VOLVO

Reference Bulletins:	Subject:	Product
Parts 00-4; 2/90	PRODUCT PLATE	CARS
	200	Group 00
1	Date: FEBRUARY 1990	No. 202

Revised Product Plate - 1990 Model Year

1990 M/Y Product Plate, second (current) version

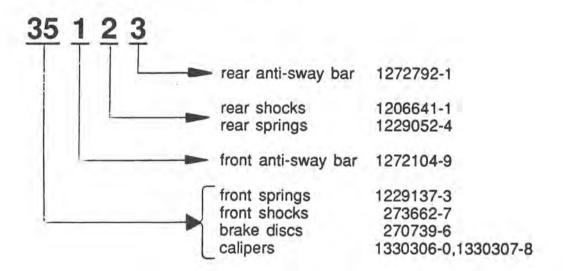
The second revision took effect in production from Week 945. (See illus. next page).

With this latest revision, positions of some codes were changed, and a 'chassis code' was added. Keys listed on the following pages give interpretations of the chassis code.

On 200-series models, the chassis code is given as a 5-digit code (item 4 above) containing the following information:

Position	Components
1,2	front springs, shocks, brake discs and calipers
3	front anti-sway bar
4	rear shocks and springs
5	rear anti-sway bar
